Remaining gaps for EEE in 40/100G

Hugh Barrass
IEEE P802.3bj
November, 2012

D-1.1 – Comment #68, 69

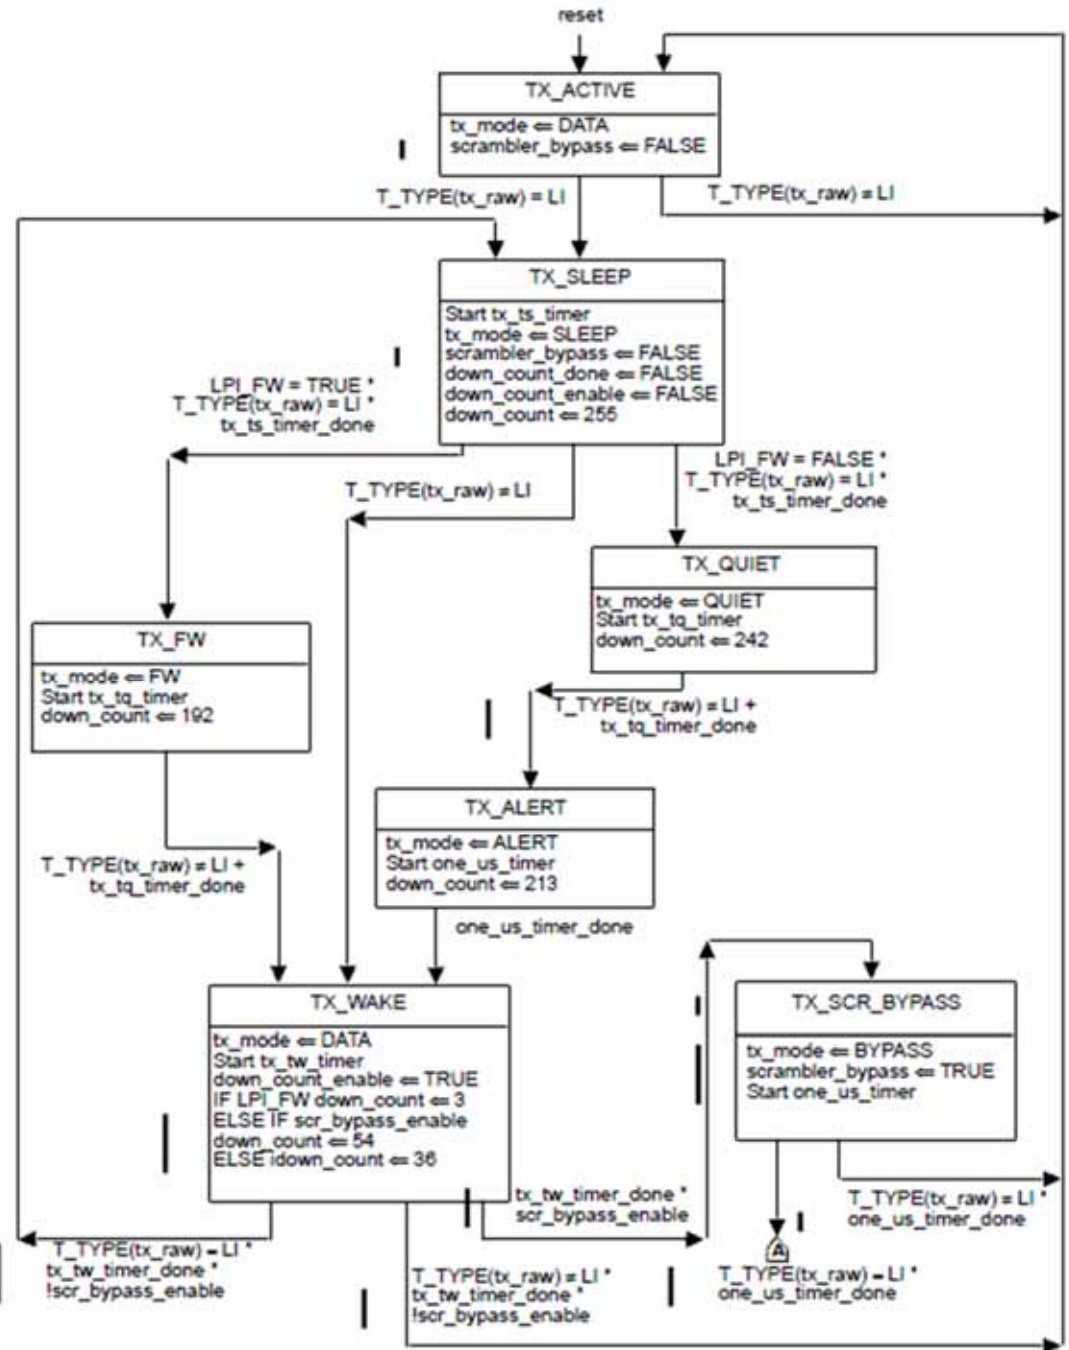
- ▶ A proposal that Clause 74 should be changed to require FEC to resynchronize based on RAMs was rejected...
 - It was preferred to keep existing FEC implementations unchanged
- ▶ Therefore scrambler bypass must be used as defined in Clause 49.
- ▶ This will add 2uS to normal wake with FEC.
 - This is acceptable because FEC latency is slow anyway; Fast Wake is available; & such implementations are rare anyway
